STAFF CASE REPORT TO PLANNING COMMISSION

Subdivision Case Number:	2016-006	PC Meeting Date: 01-11-16
Subdivision Name:	Riverview Terrace Resub of Lots 6 and 7 Urban Infill Lot Compatibility Option	
Applicant Request:	Urban Infill Lot Compatibility Option	
Property Location:	910 Young Avenue	
Property Owner:	Ben Hagaman	
Applicant:	Ben Hagaman and Northpointe Surveying	
Total Acreage:	0.31 Acres	
Proposed Density:	6.45 dwelling units per acre	
Tax Map Number:	136A-S-021	
Zoning:	R-1 Residential Zone	
Staff Recommendation:	APPROVE, Urban Infill Lot Compatibility Option

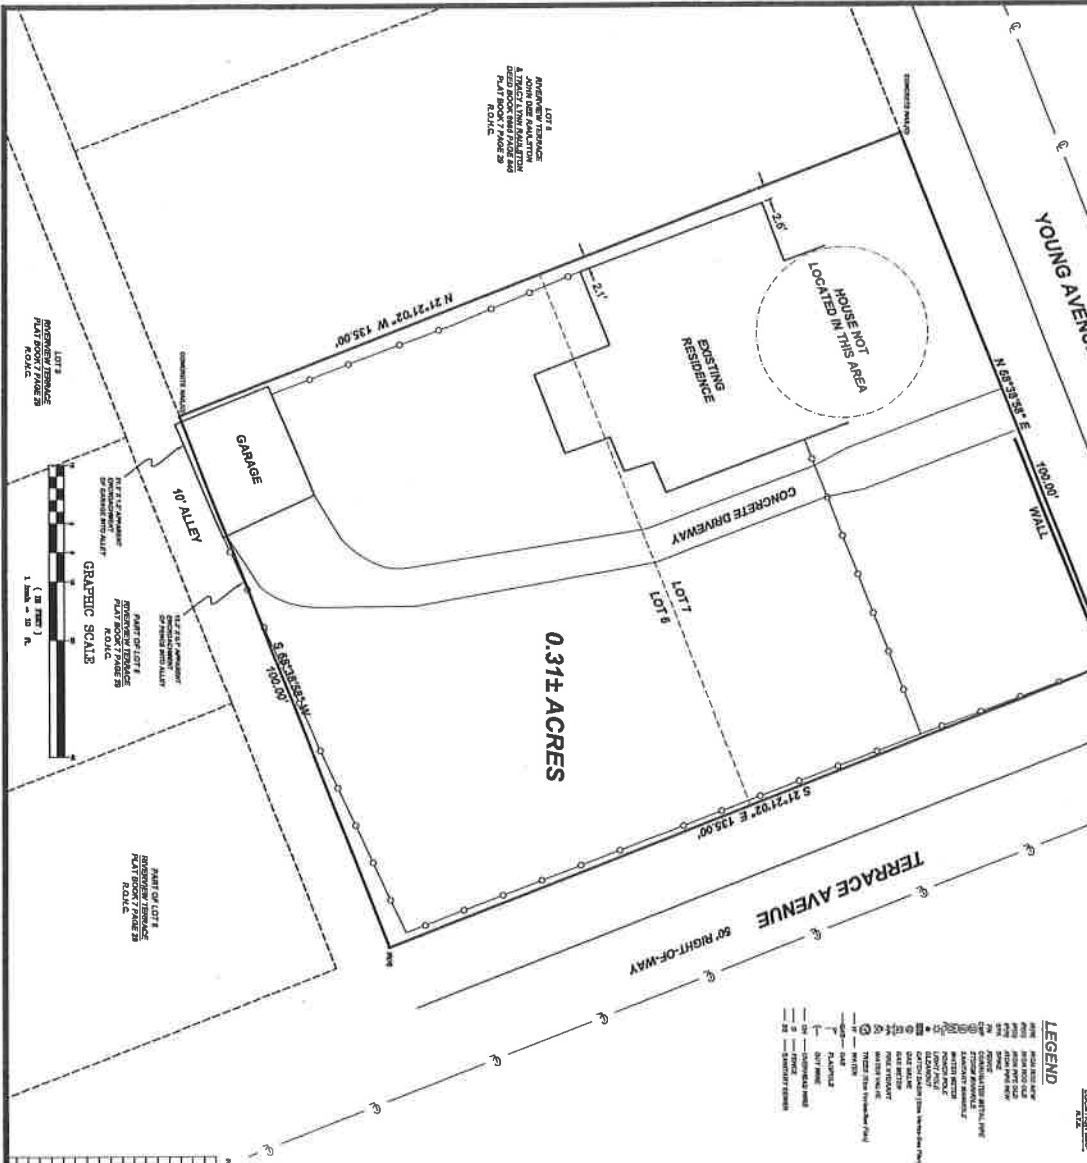
If the infill lot is an interior lot there shall be a side yard of not less than five (5) feet. The 5' side yard setback is the minimum required and meets the requirements of section 38-480 of the Chattanooga Zoning Ordinance. The proposed side yard setback for the existing and proposed structures on Lots 1 and 2 appears to be a minimum of 5' in compliance with the provisions of the Chattanooga Zoning Regulations.

There shall be a rear yard setback of 25'. The 25' rear yard setback is the minimum required and is in compliance with section 38-480 of the Chattanooga Zoning Ordinance. The proposed rear yard setback for the existing and proposed structures on Lots 1 and 2 appears to be a minimum of 25' in compliance with the provisions of the Chattanooga Zoning Regulations.

For infill corner lots the setbacks depends on the lot size frontage. Lots with 50' or less of frontage shall have a 10' setback. Lots with frontage of between 50.1' and 60' shall have a setback of 10'. Lots with 60.1' or more of lot frontage shall have a 25' setback.

Approve the Urban Infill Lot Compatibility Option
